# Access Compliance Report

## Public Rights-of-Way

Intersection ID: 7091	Main Street: BROOKSHIRE_BV	Cross Street: HOVIS_RD	Location: S
ADA ID: 10887767CEE4	Ramp Type: Perp	Initial Pass/Fail: Fail	Overall Compliance: No
Severity Score: 21.25			
Codes/Mitigation Info/Possible Solution		Field Measurements/Component Compliance

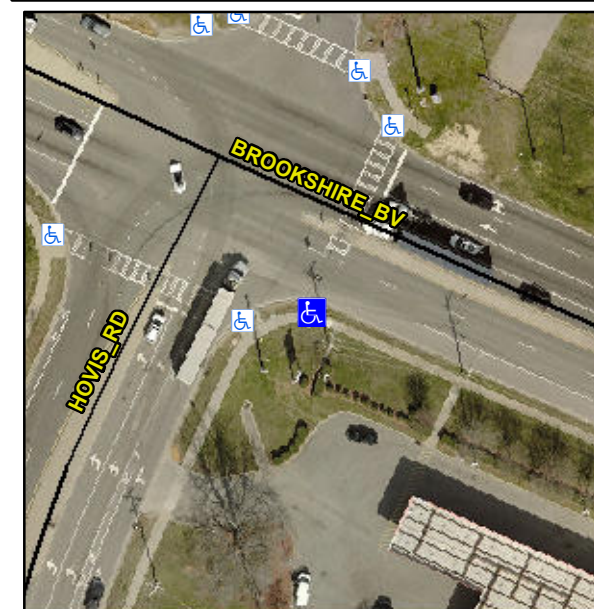
**Not Found, R304.5.1, R304.2.2**

Compliance	Description	Data	Compliance	Description	Data
N/A	Ramp Length (in)	53.0	No	Ramp Slope (%)	11.0
No	Ramp Width (in)	46.5	Yes	Ramp XSlope (%)	1.9
N/A	Flare Type LT	N/A	N/A	Flare Type RT	N/A
N/A	Flare Slope LT (%)	N/A	N/A	Flare Slope RT (%)	N/A
N/A	Flare Traversable LT?	N/A	N/A	Flare Traversable RT?	N/A
N/A	Landing Length (in)	N/A	N/A	DWS Provided?	N/A
N/A	Landing Width (in)	N/A	N/A	DWS Contrast?	N/A
N/A	Landing Slope (%)	N/A	N/A	DWS Length (in)	N/A
N/A	Landing X Slope (%)	N/A	N/A	DWS Full Width?	N/A
N/A	Landing Curb? (Y/N)	N/A	N/A	DWS Offset (in)	N/A
N/A	Shared Landing?	N/A			
N/A	Gutter Ponding?	N/A	N/A	Gutter Slope (%)	N/A
N/A	Gutter Lip Ht (in)	N/A	N/A	Gutter X Slope (%)	N/A
N/A	Painted X Walk1?	No	N/A	Painted X Walk2?	N/A
	X Walk 1 Direction	To NW		X Walk 2 Direction	N/A
N/A	X Walk 1 Width (in)	N/A	N/A	X Walk 2 Width (in)	N/A
	X Walk 1 Slope (%)	3.8		X Walk 2 Slope (%)	N/A
	X Walk 1 X Slope (%)	1.6		X Walk 2 X Slope (%)	N/A

**Remove & Replace Entire Ramp.**
